We are also of the opinion that it would be unreasonable to grant planning permission without an assessment being undertaken. We anticipate that an assessment may show that some adjustment to the design is needed in order to reasonably safeguard the amenity of [REDACTED] Bembridge Drive. This is discussed further below, with reference to specific objective tests used to assess natural lighting.

Application of BRE Site Layout Planning for Daylight and Sunlight: A guide to good practice

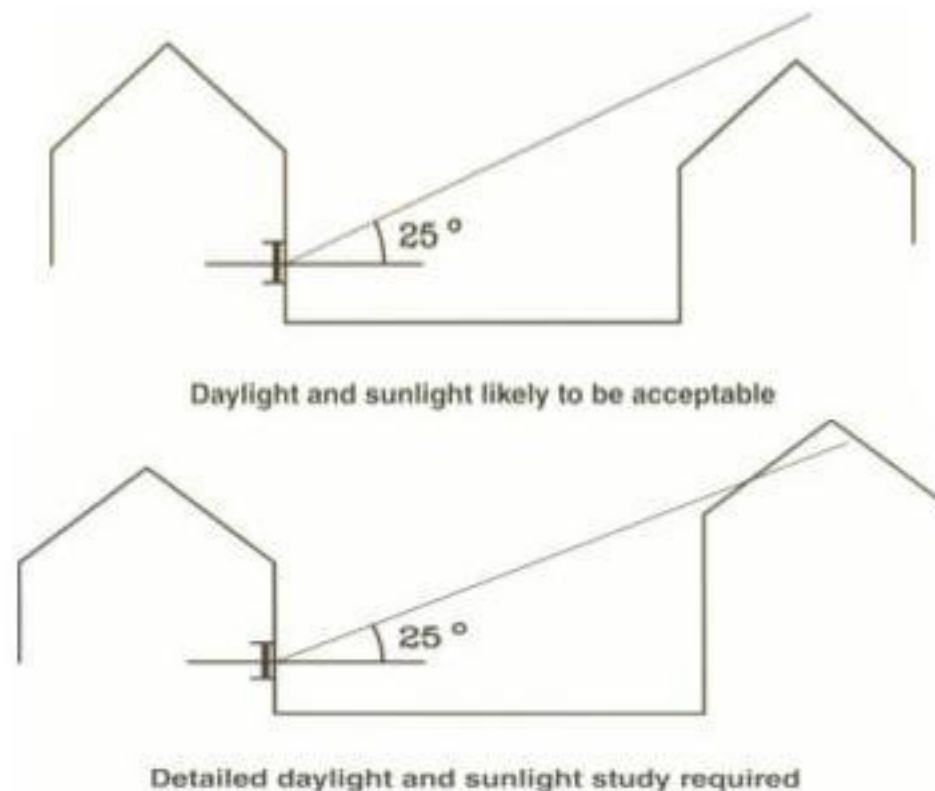
The ground floor side bedroom window at No. [REDACTED] Bembridge Drive already enjoys a relatively low level of daylight and sunlight due to the close proximity to No. 2 Bembridge Drive. The photograph below indicates the approximate distance between the two properties. Additionally, you will note that there are two ground floor side windows, one serving a [REDACTED] Skylights to the first and second floors will also be impacted.
